**SAN LEANDRO SENIOR CENTER-PHASE 1  
PROJECT NO. 06-210-18-116**

**ADDENDUM NO. 4**

August 15, 2007

1 MONUMENT SIGN  
SCALE: 1/2" = 1'-0"

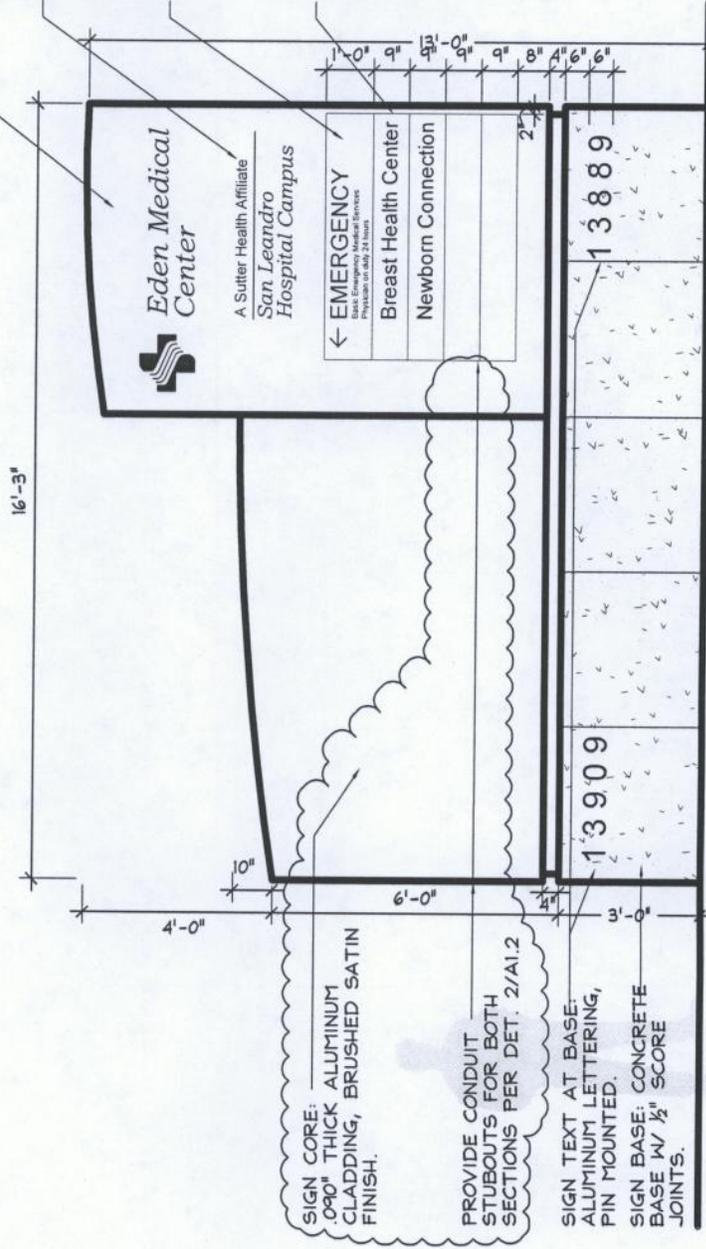
**Sheet A1.2, Detail 1:**

Monument sign has been revised per attached detail.
